# **ADDENDUM NO. 1**

**TXDOT AVIATION DIVISION  
AIRFIELD LIGHTING AND REMARKING  
at  
NORTH TEXAS REGIONAL AIRPORT (GYI)  
DENISON, TX**

**TXDOT PROJECT NUMBER 2501DENSX-REBID**

# ADDENDUM NO. 1

COVER SHEET

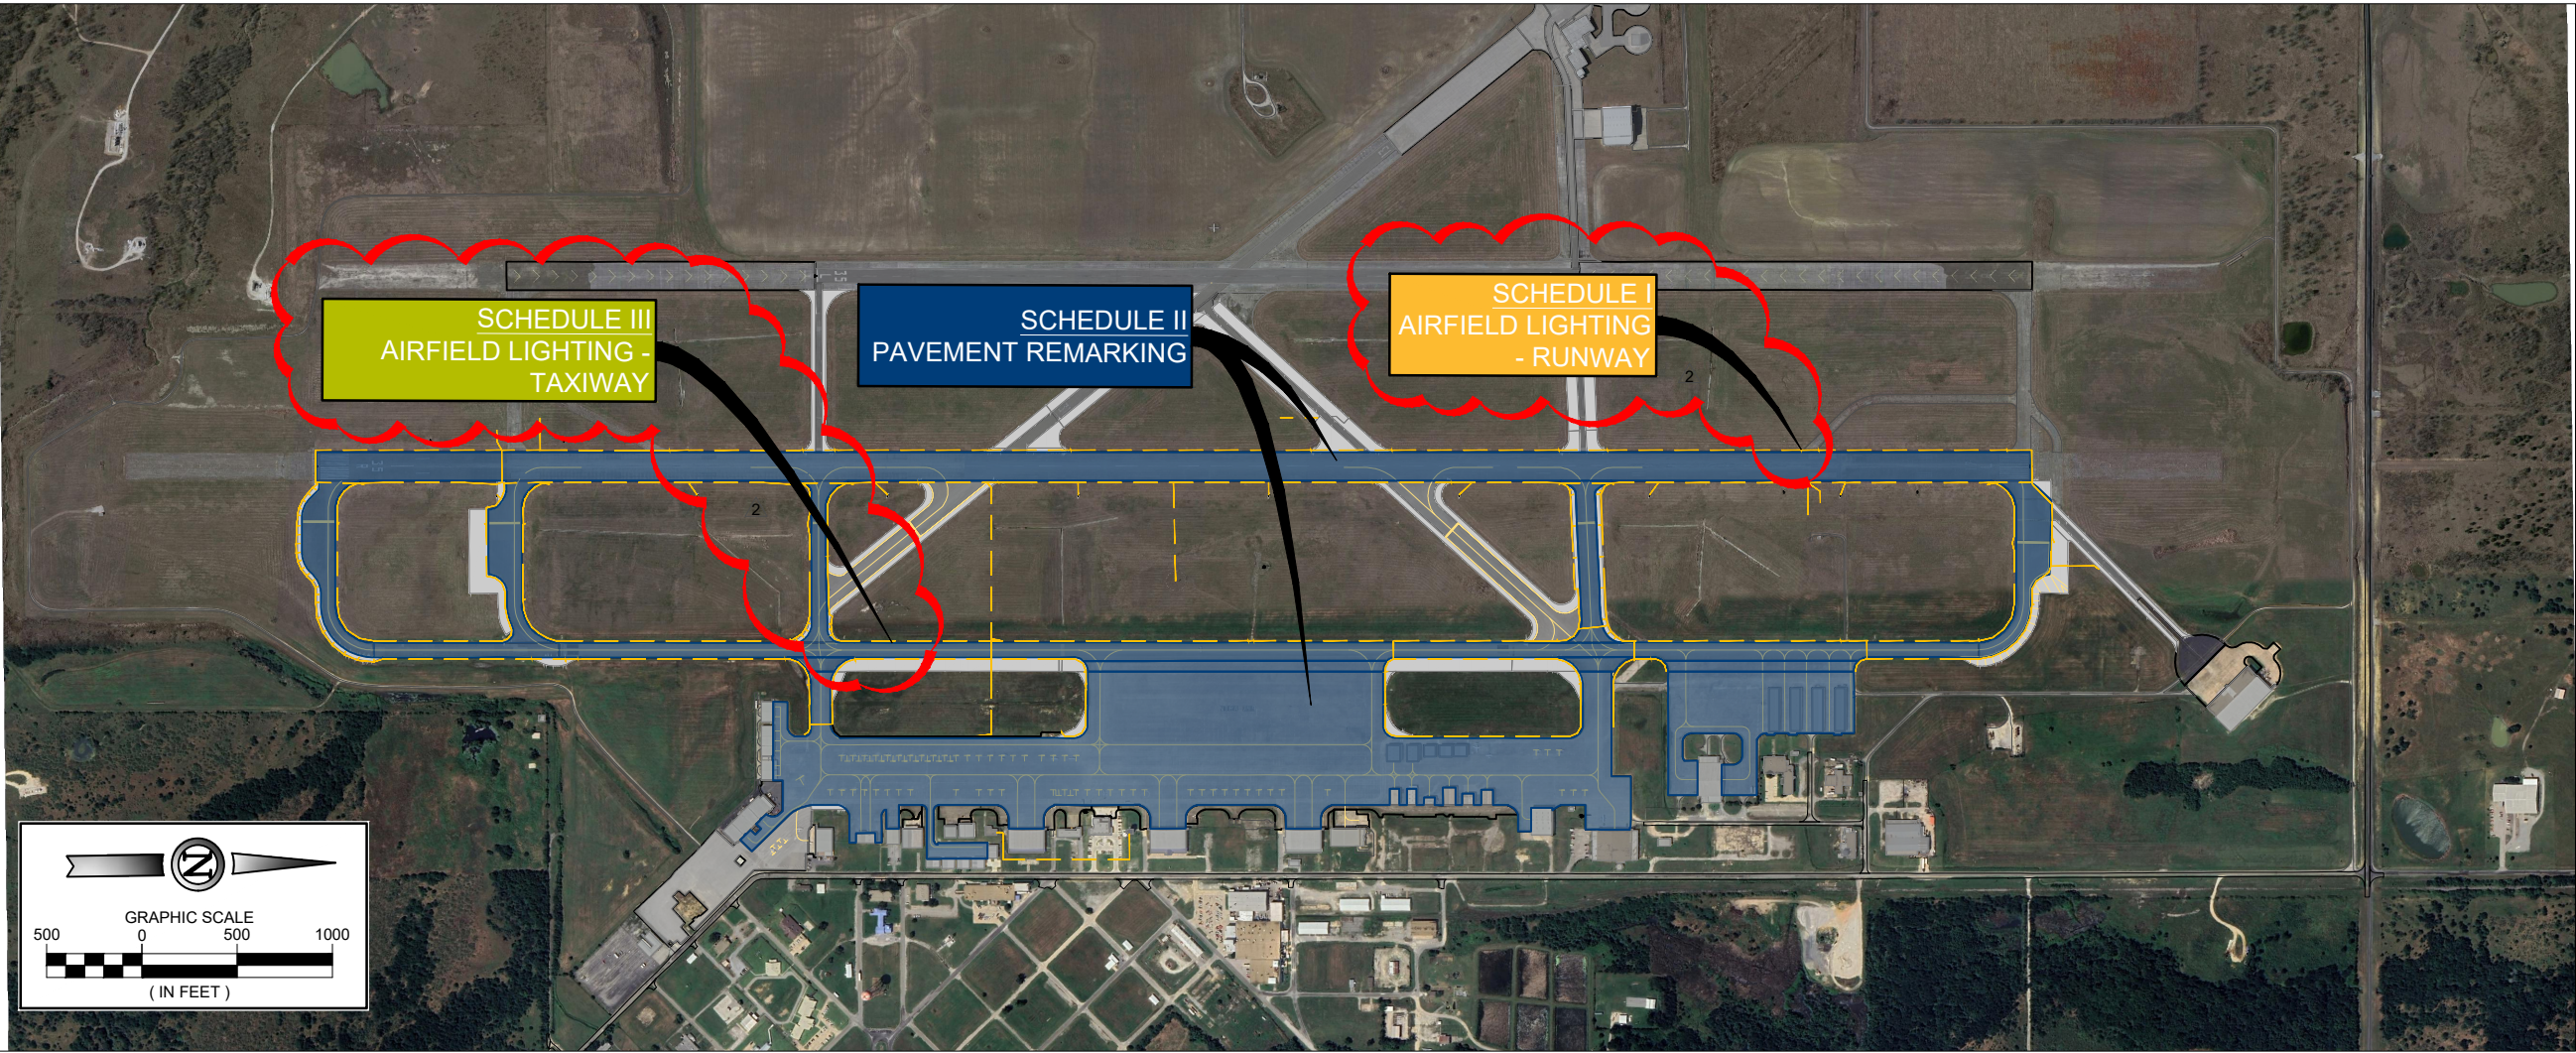
1. Sheet Title.: COVER SHEET  
Sheet No.: 1  
Revision: Added a new schedule of work for the taxiway lighting installation elements, Schedule III Airfield Lighting – Taxiway, and updated Schedule I to reflect just the runway lighting elements to be installed during that schedule.  
Justification: Instead of all the runway and taxiway lighting to be installed in one schedule, it was broken up into two schedules, one for runway lighting and one for taxiway lighting. See attached.
